The purpose of this letter is to describe a list of scheduled actions to be completed at the Lehigh Permanente Quarry to address the deficiencies noted by Kit Custis, County appointed inspector, on his February 28, 2013 site inspection.

Per Condition of Approval 78 (COA 78) of the Final Conditions of Approval, the Mine Operator shall implement stormwater and sediment management controls in addition to general BMPs required by the SWPPP in active and inactive reclamation areas throughout Phase I, II, and III of the RPA.

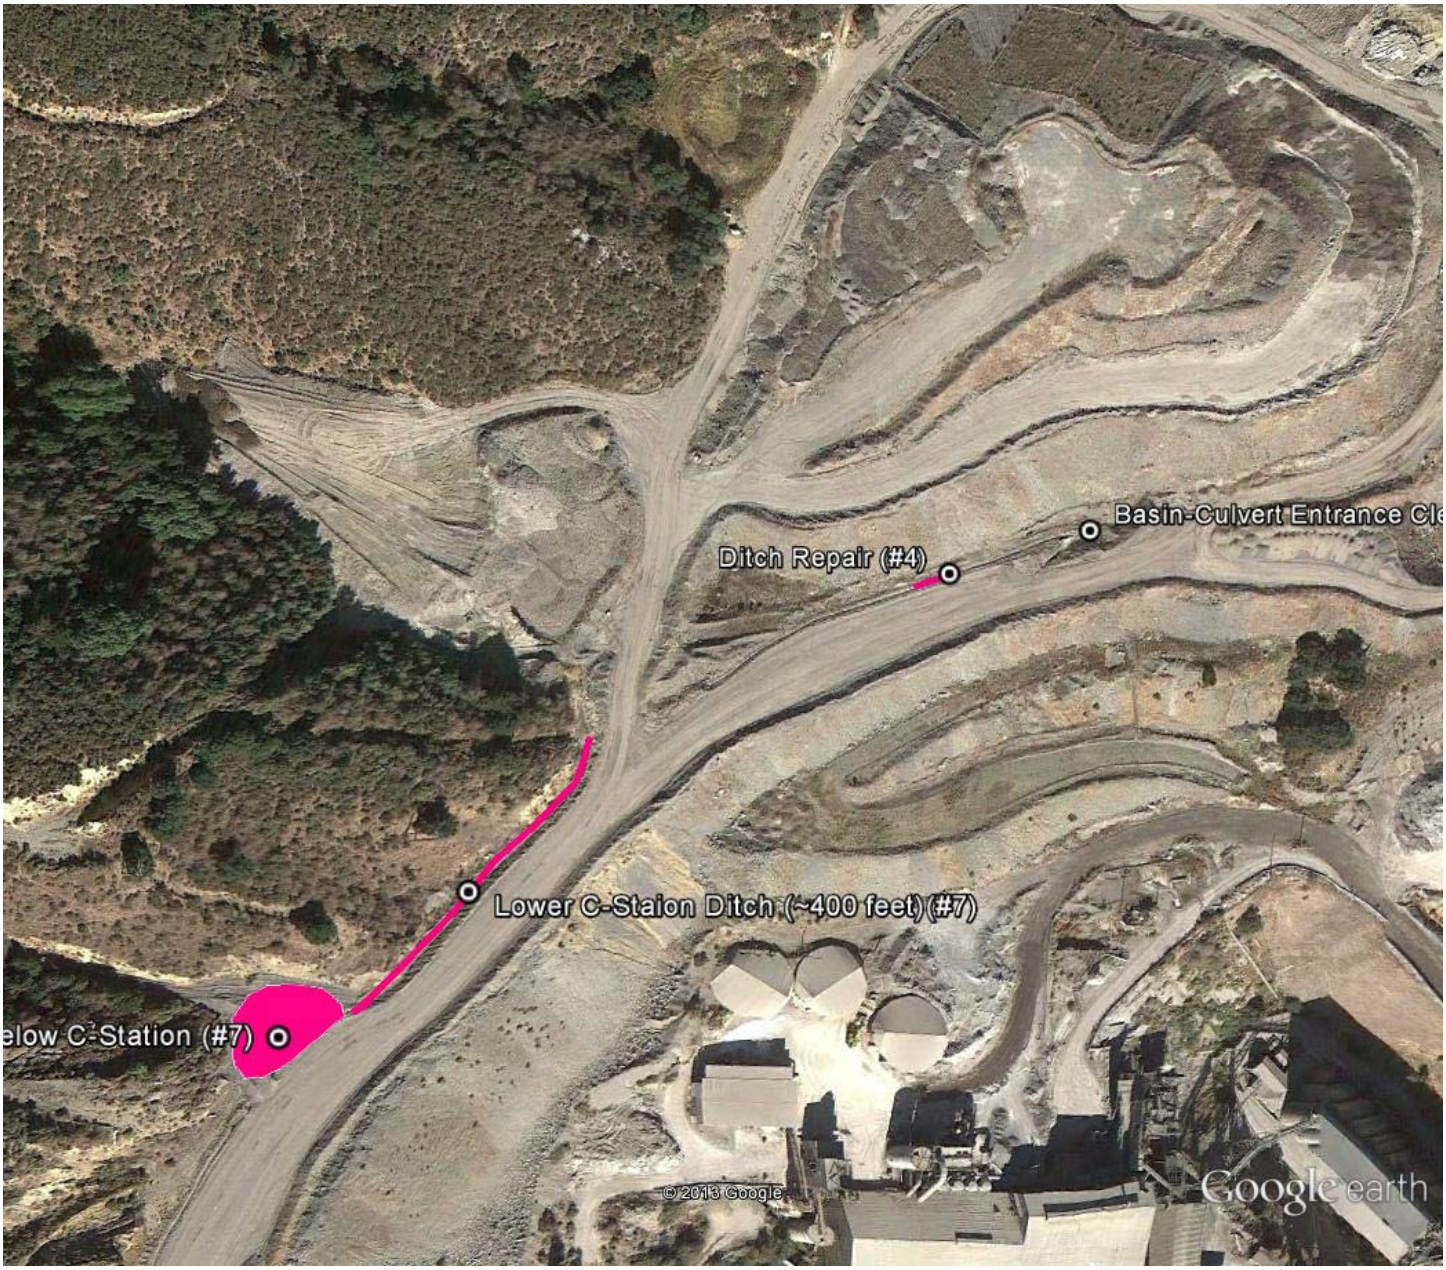
4. Cleanout and minor repair because of breakouts needed in some areas of the drainage ditches in EMSA.

5. Replacement of Pond 30 outfall rock with non-limestone is still required.

6. BMPs such as ditch drains will likely be needed and repairs made before storm events to prevent run-on to stock piles.

7. Sean proposed construction of a new sediment basin and ditch cleanout.

8. Until construction of a new sediment basin, regular inspection and cleanout of the ditches will likely be needed.

10. Subarea 7 possible BMPs include regular inspection of flumes for leakage and repair, placement of erosion controls at locations where leakage or concentrated runoff occurs.

11. Siltation Basin SB-7 Cleanout

The drainage ditch along the haul road downstream from the C-Station ditches has broken out into the haul road and requires repair. Drainage ditch cleanout and repair will be performed by Coulter Gradeall. Coulter Gradeall is prepared to start work within a week of a Purchase Order confirmation and can complete the work within 10 working days. Non-limestone rock may be required and will be sourced from non-limestone overburden from the Permanente Quarry, or if that is not available, the material will be sourced from Steven's Creek Quarry. In addition, the culvert at the lower end of the ditch is filled with sediment and will require a clean out as well.

Pond 30 outfall rock replacement will be replaced by Coulter Gradall. Coulter Gradall is prepared to start work within a week of a Purchase Order confirmation. Non-limestone rock may be required and will be sourced from non-limestone overburden from the Permanente Quarry, or if that is not available, the material will be sourced from Steven's Creek Quarry. Coulter Gradeall is prepared to start work within a week of a Purchase Order confirmation and can complete the work within 10 working days.

Ditch drains will be constructed where needed to prevent runoff from stockpiles. The stockpile identified by Mr. Custis is located on the haul road above the surge pile to control surge piles north of the haul road and west of the road leading to the EMSA. Permanente staff or Coulter Gradeall will construct these ditch drains within 10 working days weeks of Purchase Order issue.

A siltation basin will be constructed below C-Station to capture all the limestone-derived materials originating from the slope uphill. It is estimated that the sediment basin will have a 15 foot diameter bottom and slopes of 1:1 and a distance across the top of 45 feet in diameter giving a volume of at least 11,500 ft^3 to capture an estimated season's worth of sediment runoff. If the potential during construction exists to increase the volume exists, this will be considered. The outer berms will be constructed of non-limestone rock sourced from Steven's Creek Quarry. Coulter Gradeall will excavate the existing limestone-derived materials and place them on the haul road for Permanente Quarry personnel to remove and dispose of. Coulter Gradeall is prepared to start work within a week of a Purchase Order confirmation and can complete the work within 10 working days.

After the construction of a new sediment basin below C-Station (see item 7 above), the ditch leading from below C-Station to the culvert downstream will be cleaned and relined with non-limestone rock sourced from Steve's Creek Quarry. Regular inspection of the drainage ditches will be conducted as necessary by WRA. Coulter Gradeall is prepared to start work within a week of a Purchase Order confirmation and can complete the work within 10 working days.

The current and future use of the water flume system in Subarea 7 will be determined by WRA and Permanente Quarry staff. If the flume system is used or connected to existing systems, regular inspection of the flume and adjacent hillsides will be conducted after each rainfall event as part of the erosion controls site inspection by WRA in accordance with the SWPPP Stormwater Best Management Practices and COA 78j.

Although not an identifiable deficiency, we propose to clean out Siltation Basin #7 southwest of the Aluminum Plant to avoid sediment runoff into aeas connected to

Permanente Creek. Coulter Gradeall cleaned this basin out at a prior time and said that it was filling. This basin receives water from the C-Station Ditches and is likely selenium-rich. It drains into the same depressions adjacent to the railroad tracks as the truck wash station does. Coulter Gradeall is prepared to start work within a week of a Purchase Order confirmation and can complete the work within 10 working days.
